Re: July 21, 2016 Commission Meeting
Agenda Item 10, Briefing on DWR's 2016 Draft Basin Boundary Modifications
Basin ID: 3-04.10 SALINAS VALLEY – CORRAL DE TIERRA AREA, 3-04.08 SALINAS
VALLEY – SEASIDE AREA

COMMENTS BY THE MARINA COAST WATER DISTRICT

Figure 1: Regional Map showing location of Adjudicated Seaside Groundwater Basin & Affected DWR Bulletin 118 Basin Boundaries

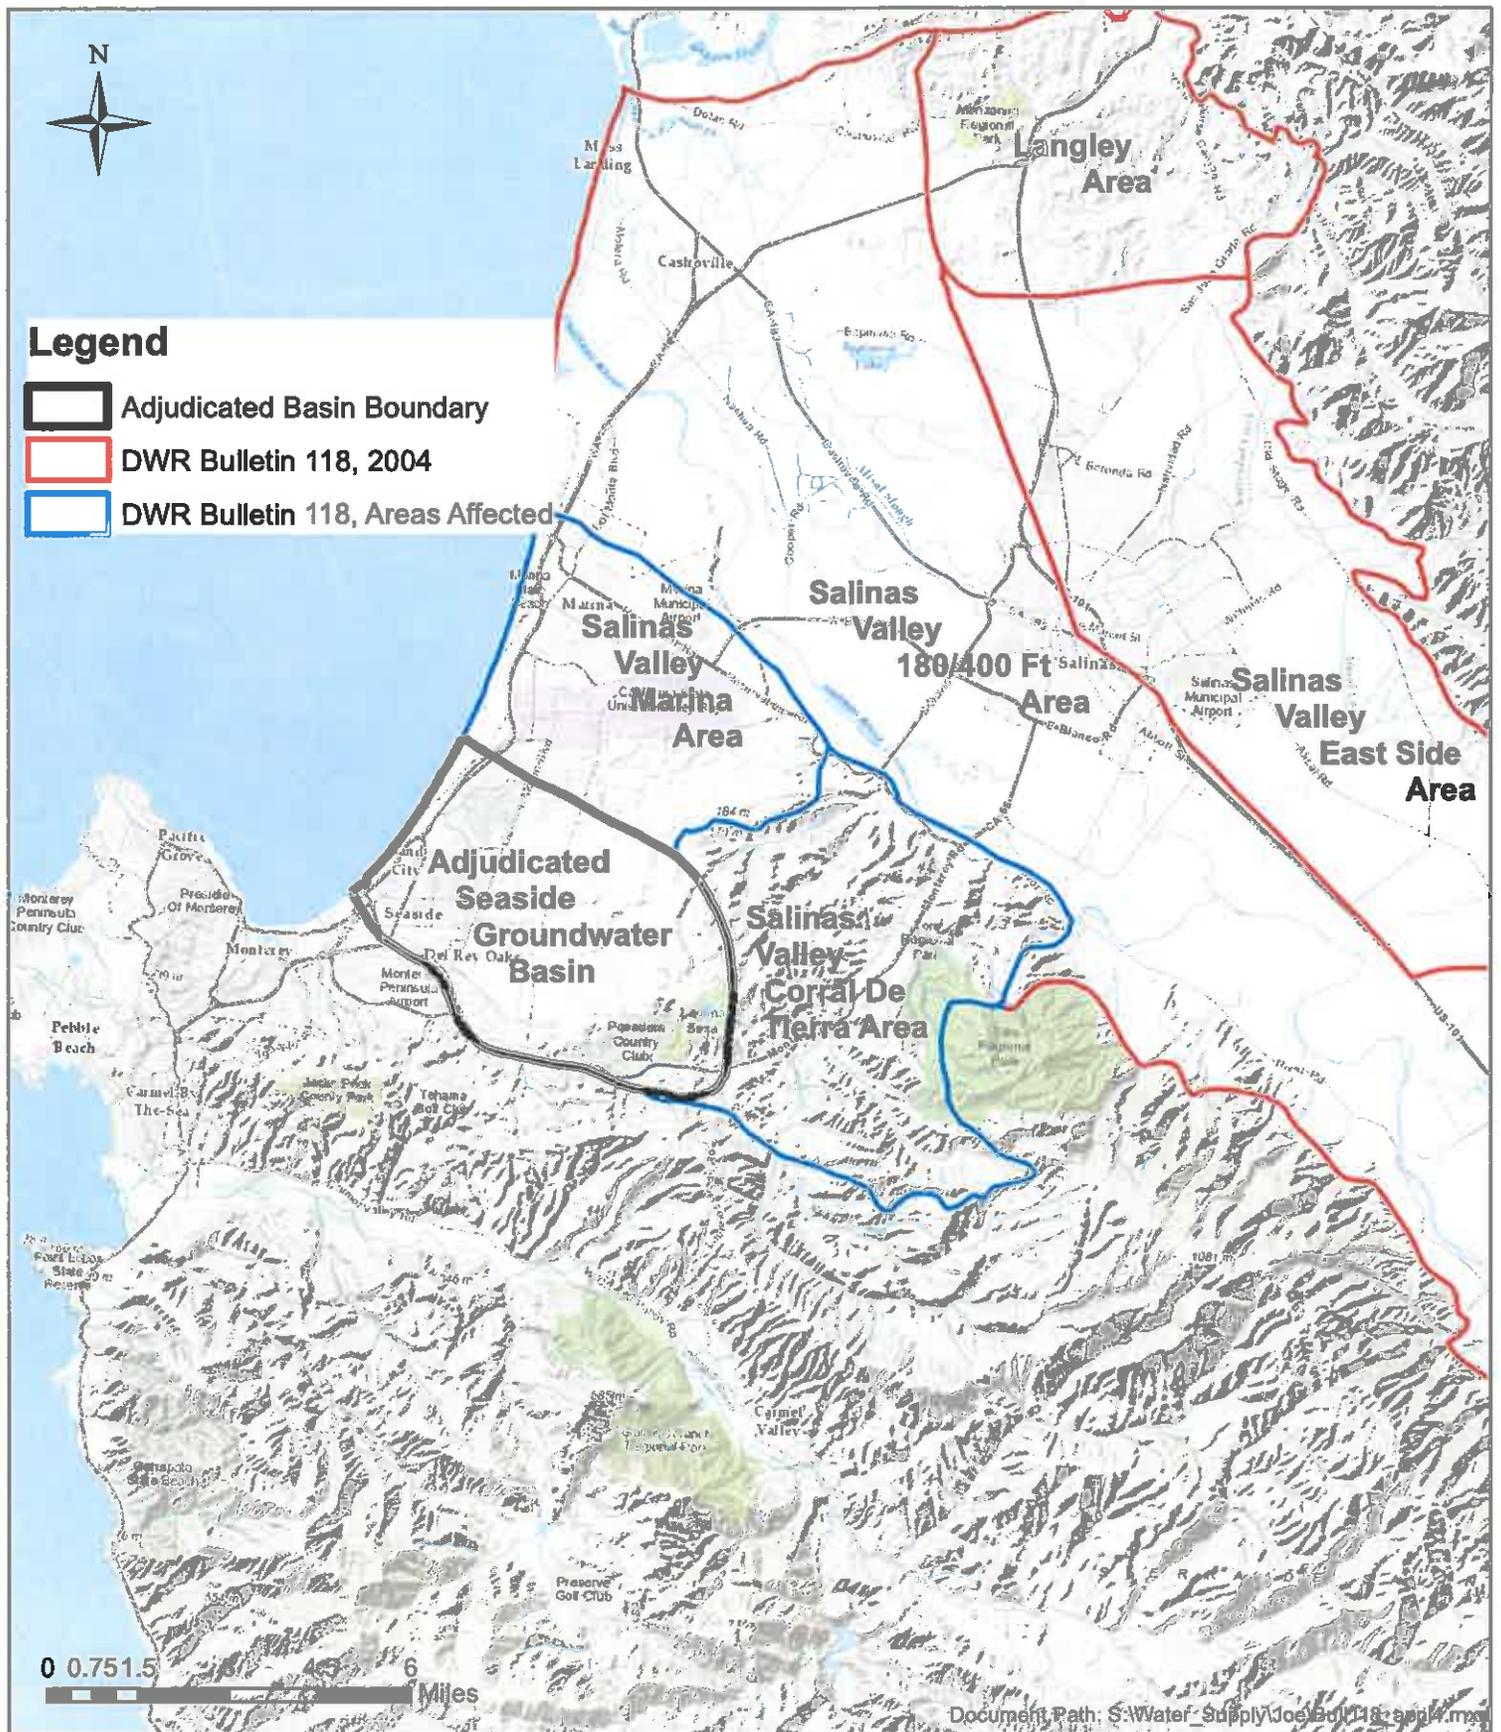
Monterey Peninsula Water Management District (MPWMD) submitted the above basin boundary request. Exhibit A to these comments is Figure 1 to MPWMD's request. MCWD supported and continues to support the basin boundary modification as specifically proposed by MPWMD. MCWD requests that you direct DWR to approve the basin boundary modifications as requested by MPWMD.

MPWMD's request included establishing the Marina Area Subbasin for that area north of the Adjudicated Seaside Basin within the existing DWR-designated Seaside Area Subbasin. The request did not include merging what is designated on Figure 1 as the "Salinas Valley Marina Area" with the "Salinas Valley Corral De Tierra Area." Exhibit B to these comments is what was posted on the DWR's Basin Boundary Modification Request System website. Note that Exhibits A and B show identical boundaries for all three groundwater subbasins.

A screen shot from the map viewer:

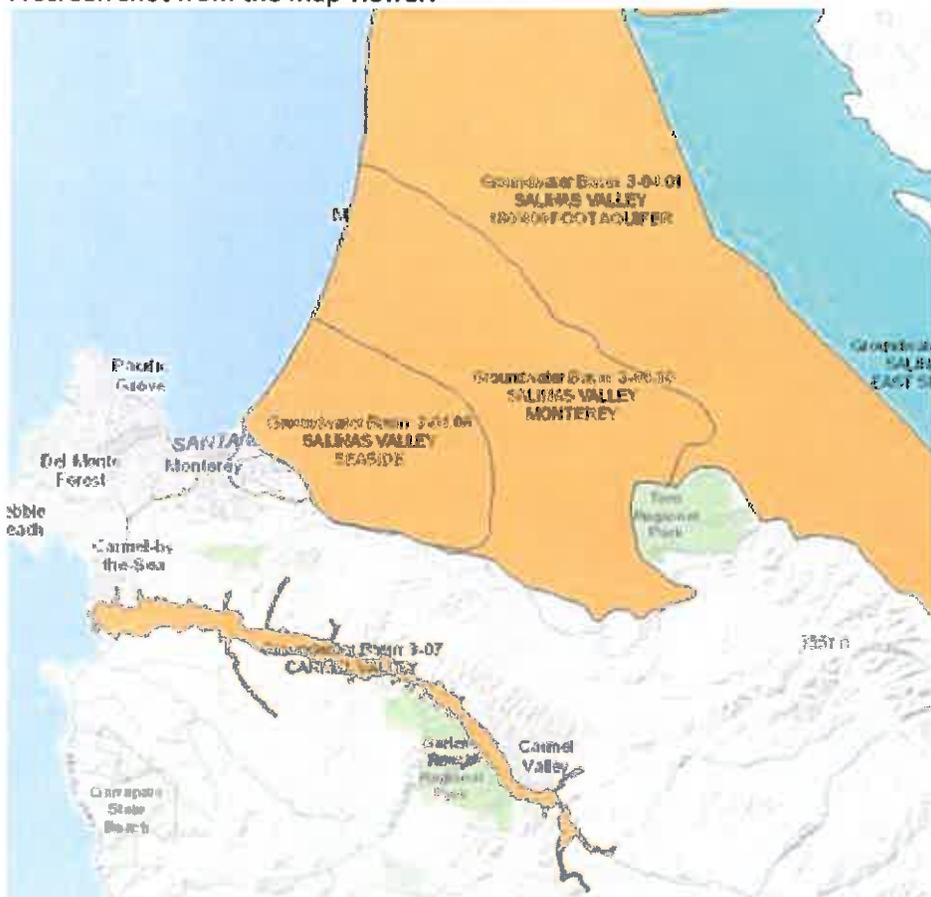
The Seaside subbasin is being split in 2. The adjudicated portion of the subbasin will remain as "Seaside", and the remainder of the old Seaside subbasin was merged with the Corral de Tierra basin to form the new "Monterey" subbasin.

So the new Monterey subbasin encompassing the old Seaside northern portion and Corral de Tierra is the modification made to the request by DWR, since the boundary modification request by MPWMD kept the northern portion of Seaside and Corral de Tierra as separate subbasins. The modification was made as the remainder of the old Seaside basin would have been too small to effectively manage as a separate groundwater basin and the USGS report showed that Seaside and Corral de Tierra were hydrogeologically connected, so the jurisdictional boundary between them was eliminated.
